# Access Compliance Report

## Public Rights-of-Way

### (Curb Ramps)

Intersection ID: 50302	Main Street: PINE_CHAPEL_DR	Cross Street: PINE_TERRACE_CT	Location: E
ADA ID: 70934003F6F7	Ramp Type: PerpDiag	Initial Pass/Fail: Fail	Overall Compliance: No
Severity Score: 10			
Codes/Mitigation Info/Possible Solution		Field Measurements/Component Compliance

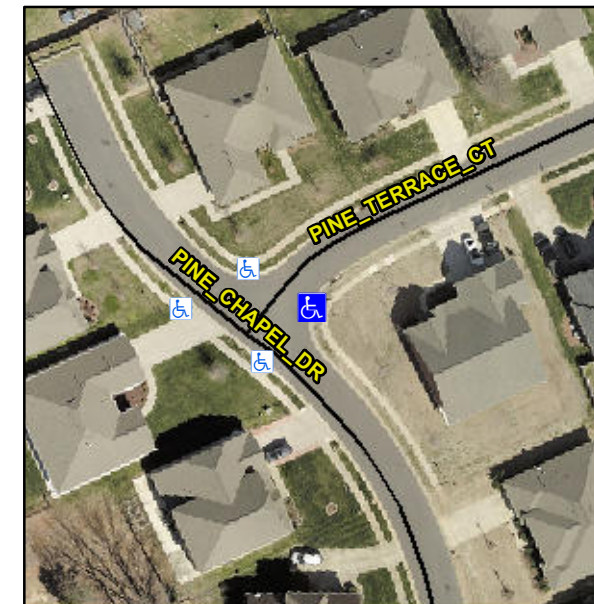
**R304.5.1, R304.5.3**

Compliance	Description	Data	Compliance	Description	Data
N/A	Ramp Length (in)	49.0	Yes	Ramp Slope (%)	5.4
No	Ramp Width (in)	47.0	No	Ramp XSlope (%)	3.0
N/A	Flare Type LT	N/A	N/A	Flare Type RT	N/A
N/A	Flare Slope LT (%)	N/A	N/A	Flare Slope RT (%)	N/A
N/A	Flare Traversable LT?	N/A	N/A	Flare Traversable RT?	N/A
N/A	Landing Length (in)	N/A	N/A	DWS Provided?	N/A
N/A	Landing Width (in)	N/A	N/A	DWS Contrast?	N/A
N/A	Landing Slope (%)	N/A	N/A	DWS Length (in)	N/A
N/A	Landing X Slope (%)	N/A	N/A	DWS Full Width?	N/A
N/A	Landing Curb? (Y/N)	N/A	N/A	DWS Offset (in)	N/A
N/A	Shared Landing?	N/A			
N/A	Gutter Ponding?	N/A	N/A	Gutter Slope (%)	N/A
N/A	Gutter Lip Ht (in)	N/A	N/A	Gutter X Slope (%)	N/A
N/A	Painted X Walk1?	No	N/A	Painted X Walk2?	No
	X Walk 1 Direction	To NW		X Walk 2 Direction	To SW
N/A	X Walk 1 Width (in)	N/A	N/A	X Walk 2 Width (in)	N/A
	X Walk 1 Slope (%)	0.8		X Walk 2 Slope (%)	1.3
	X Walk 1 X Slope (%)	0.6		X Walk 2 X Slope (%)	2.1

**Remove & Replace Curb Ramp With Two New Directional Ramps or Equivalent.**
